Monthly Specification Update

Intel® Server Board S2600WP Family
Intel® Server System H2000WP Family

Intel Order Number G64830-012

January, 2015

Figure 1. The Chassis Quick Reference with Incorrect Picture Titles

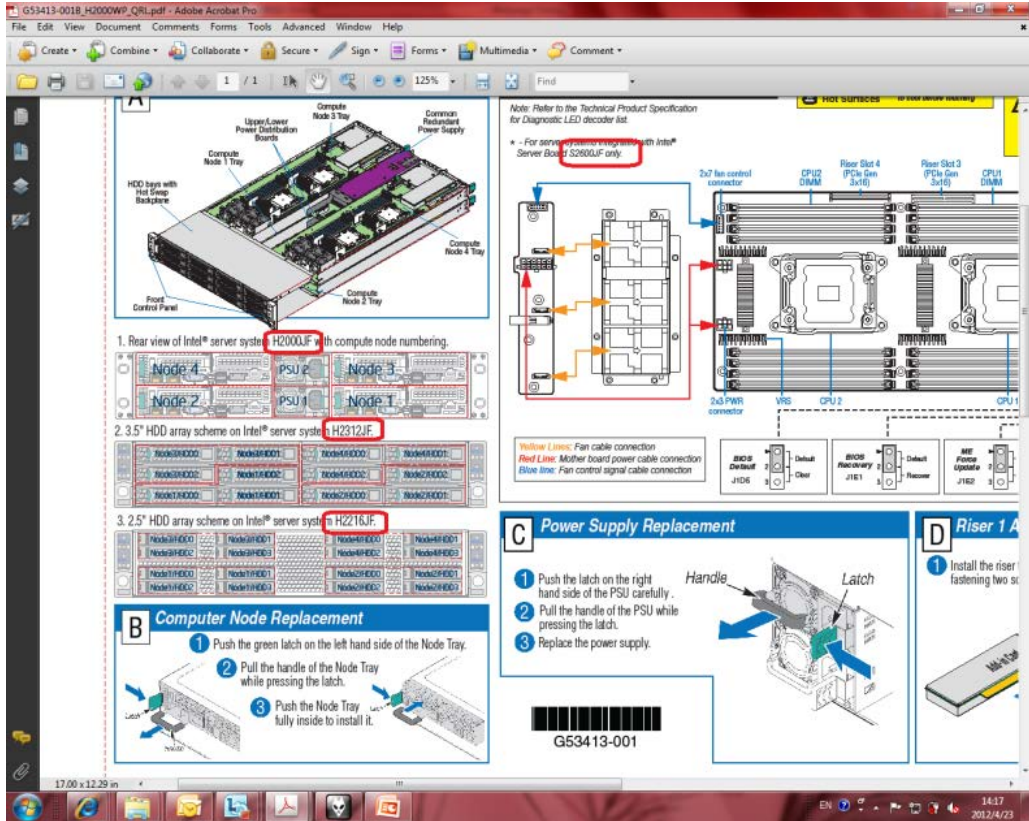
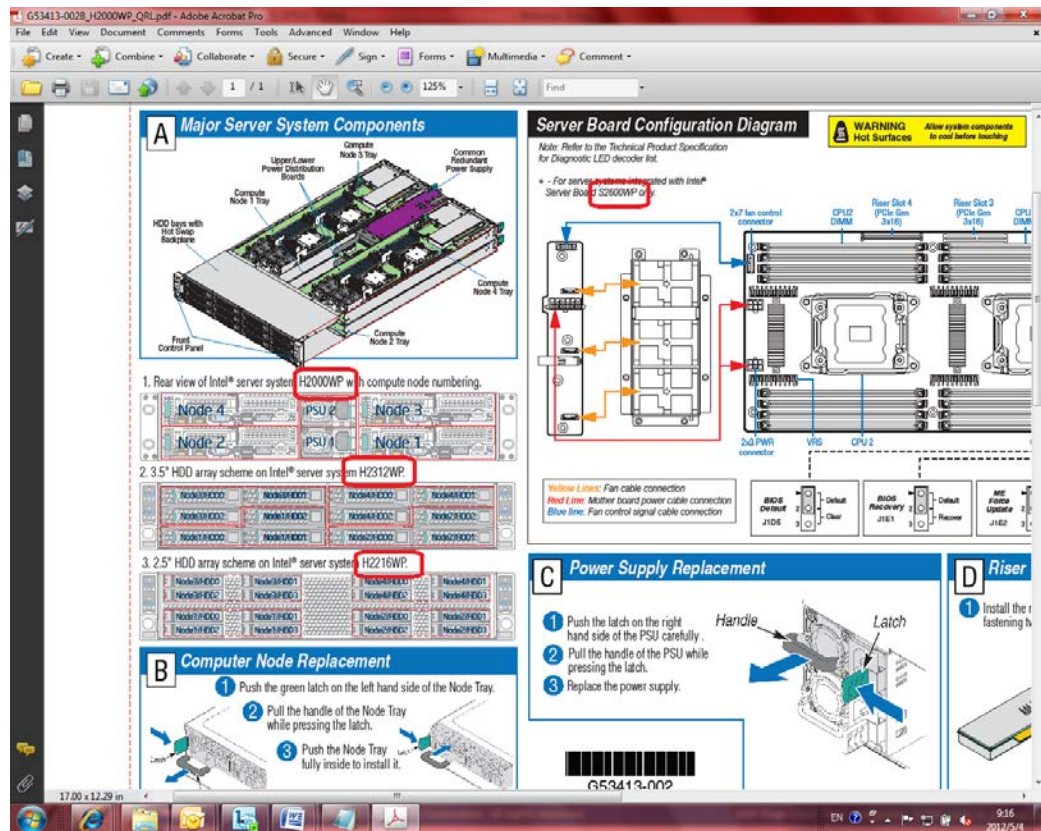
19. Incorrect picture titles in the Chassis Quick Reference

Problem The *Intel® Server System H2000WP Family Chassis Quick Reference* (document ID G53413-001) has four incorrect picture titles as shown below. The correct title names should be "H2000WP", "H2312WP", "H2216WP", and "S2600WP". All schemes and configuration diagrams are correct for H2000WP. The impacted servers systems are listed in the table below. This problem has been fixed in the updated Chassis Quick Reference (document ID G53413-002).

Implication The picture titles do not match the pictures.

Figure 2. The Chassis Quick Reference with Updated Picture Titles

Status This issue is fixed with G53413-002.
